Preferred Project Report  
Site 8a, Sydney Olympic Park  
Major Project 06\_0175  
Prepared for Watpac Developments Pty Ltd  
February 2008

This report responds to each of the issues raised by the authorities.

### 3.1 SOPA Submissions

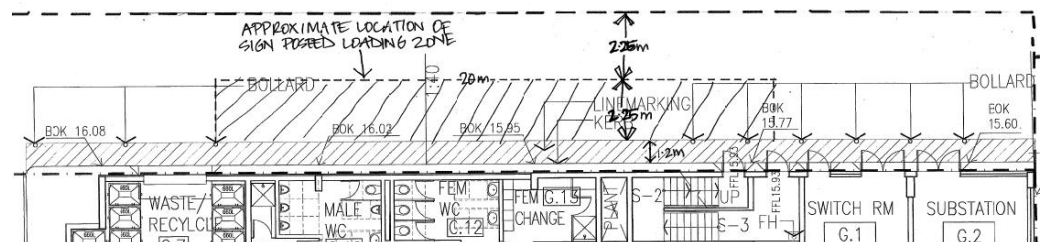
- 3.1.4 *The EA indicates that deliveries will be made via the service lane, which is supported. However, it also states that parking/deliveries/couriers at the rear of the building will be supplemented with on-street parking spaces in Murray Rose Avenue- this is not supported and any parking of vehicles on Murray Rose Avenue will need to comply with regulatory parking conditions.*

It is proposed that a 20m long 'Loading Zone' be signposted along the southern side of the service lane, east of the car parking spaces. The single direction service lane from the bollards to boundary line is 4.5m wide and therefore able to accommodate two cars abreast. As such a vehicle parked in the loading zone would not impede a second vehicle passing in the same direction.

The proposed bollards along the rear of the building will also ensure that the line marked pedestrian access route is kept clear even when the signposted loading bay is in use and that access for the NSW Fire Brigade would be maintained. The approximate location of the loading zone is shown below.

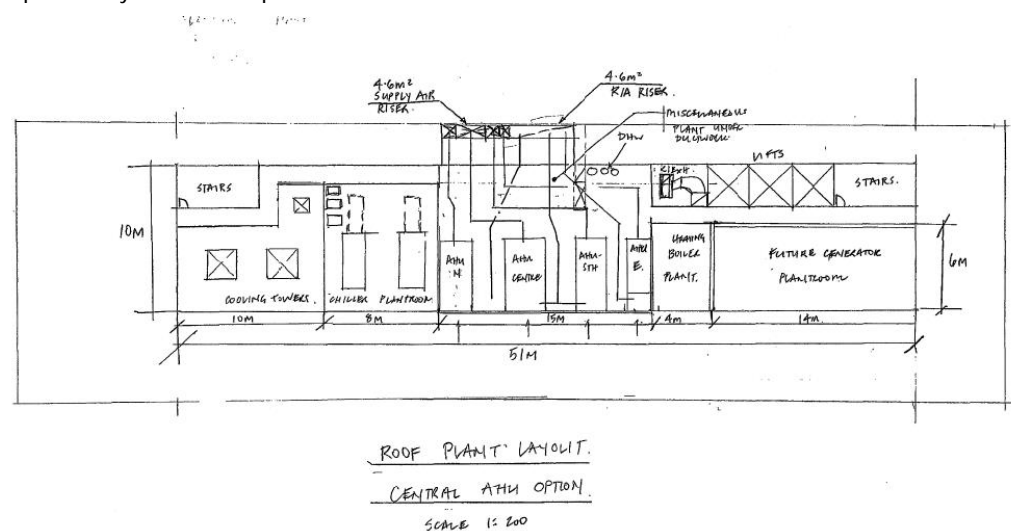
#### 3.2.12 Clarify the intended use and need for a future generator area on the rooftop and why it can not be accommodated in the nominated plant areas which are extensive.

An area measuring 6m by 14m has been reserved on the roof plant for a back up generator plant. The generator plant will only be installed on the roof to provide back up electricity on a temporary basis when required. The space provision for the tenant generator is required for classification as an A-grade office building under the Property Council of Australia.

The back up generator plant has been located in its current position as there is limited space in the main plant areas. As demonstrated in a draft detailed design plan for the plant area below, ducts will be connected between the risers and the air handling units, which significantly reduces the amount of space available on the plant.

A preliminary detailed roof plan is shown below:
